UNITED STATES PATENT AND TRADEMARK OFFICE

APPLICATION NO.	FILING DATE	FIRST NAMED INVENTOR	ATTORNEY DOCKET NO.	CONFIRMATION NO.
10/670,806	09/25/2003	Malte Blomeyer	2001P04429WOUS	7583

Office Action Summary

DETAILED ACTION

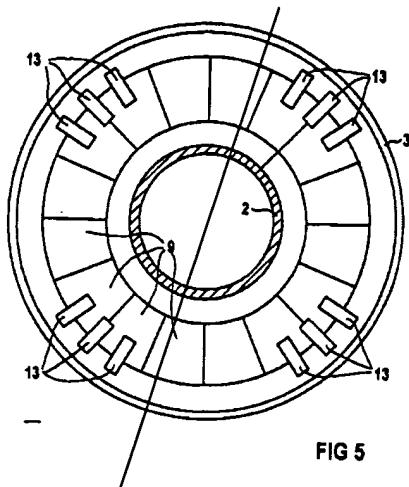
10. Claims 1-3, 7-20 are rejected under 35 U.S.C. 103(a) as being unpatentable over Becker (6,152,724) in view of Becker (5,451,160). Becker '724 teaches the blocking members 13 in the inlet region but not in the upstreammost portion, i.e. at the outer

periphery situated at the air inlet. Becker '160 shows a blocking projection at the upstreammost portion, at the outer periphery, situated at the air inlet. It would have been obvious to one of ordinary skill in the art to place the blocking projections at the upstreammost portion at the outer periphery of the air inlet, as a well known location for protrusions. It is not clear whether Becker '724 will have the recirculation zone toward the outer periphery. However, Becker '160 also teach an outlet structure of the burner, which appears identical to that disclosed in the present application, and a recirculation zone at the outer periphery of the outlet is inherently present as the outlet configuration of Becker '160 appears identical to that of the disclosed invention and it is well known in the art that the sudden expansion of the flow at the outlet will inherently cause recirculation zones. It would have been obvious to one of ordinary skill in the art to employ the outlet configuration of the Becker '160, as a well known alternative outlet configuration contemplated for the burner type of Becker '724, where such a configuration will inherently produce the claimed recirculation. Becker appears to illustrate the claimed blocking area ratios of the blocking members. In order to obviate any doubt, it would have been obvious to one of ordinary skill in the art to employ the claimed ratios, as an obvious matter of finding the workable ranges in the art. As for distributing the blocking members asymmetrically, Becker '724 does allow for non-circular symmetry (see Fig. 5) and depending on the axis on which the axis is taken will also appear asymmetric. Alternately, Becker also would teach one of ordinary skill to

allow for some variation from symmetry to accommodate burner inlet tolerances and deviations from the idealized case.

asymmetric about this line
